SECTION **9**

Project Constructability Part A, Part B and Part C

THIS IS **ONE** SECTION OF **TWENTY TWO,**
THAT FORMS PART OF A LARGER GROUP SUBMISSION
TO THE NEW ENGLAND REZ TRANSMISSION PROJECT
SSI-74175972

GROUP EIS SUBMISSION FOR THE NEW ENGLAND REZ TRANSMISSION PROJECT | SSI-74175972

> Figure 2 Profile of the 192 km transmission alignment from Bayswater to Central South Hub, reproduced in the Scully meeting brief, p. 8. [1]

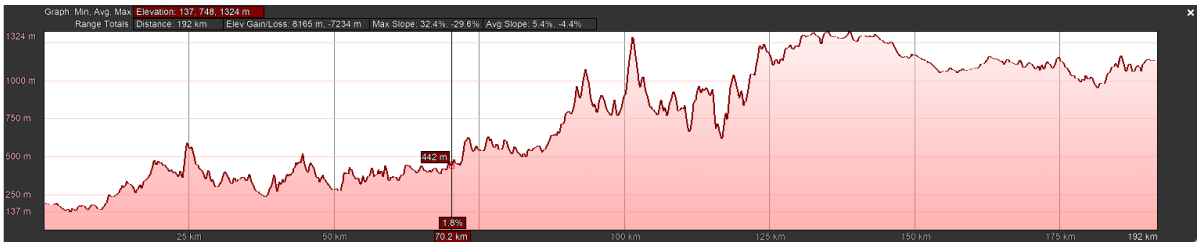
The profile shows the elevation of the transmission alignment itself. It does not show the additional difficulty of constructing access tracks across natural side slopes, reaching individual tower sites, establishing level tower pads or moving cranes, concrete trucks and other heavy equipment between work fronts.

The profile confirms that this is an exceptionally demanding construction corridor. Even before access-track gradients, wet-weather delays and individual tower-site constraints are taken into account, the route's length, cumulative elevation change, steep maximum slopes and prolonged exposure to high-altitude conditions create substantial risks of reduced productivity, construction delays and cost escalation.

Figure 2 - Profile of transmission corridor across "Osland". Note that the average slope is 14.6%. Max slope is 38.2%.

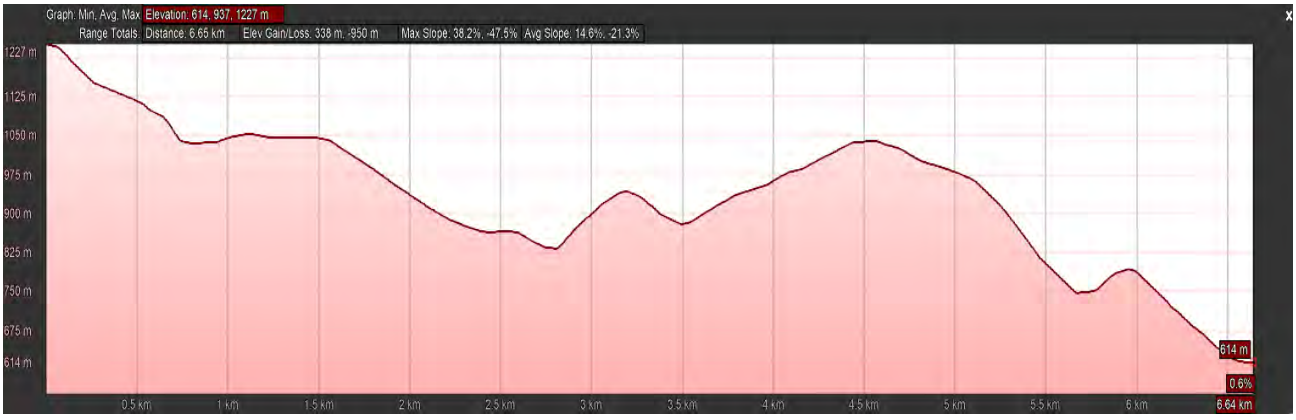
Our farm track that the transmission line access track is closely aligned to is forced to pass through basalt scree slopes of 30-40 degree slope resulting in road cut heights of 4m+ to achieve a 4.5m track width. There are several tight switchbacks - full lock turning for a toyota landcrusier - and a gradient of up to 16 degrees. Construction of a 10m wide gravel formed road down this track - which is currently a dry weather only basalt soil track- will pose several issues of extreme and excessive nature. it will require road cut heights of 8m+ with greater cut height impact overtime as the initial cut slumps onto the road.
